Improved track control arm BMW E46

SIDEM	APPLICATION	N° OE
21278 R	Track control arm	BMW (E46)	31 12 6 777 851 R
21279 R	Track control arm		31 12 6 774 820 R

OE design

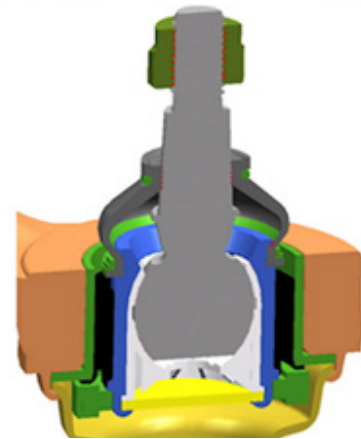
- Early wear of rubber bedding ball joint.
- Play on ball joint.

- Weak connection by rubber between inner and outer bushing.
- Damaged dustcover.

- A new ball joint is progressed without the rubber core.
- A cover is added to protect the pin and the dustcover during transport and storage.
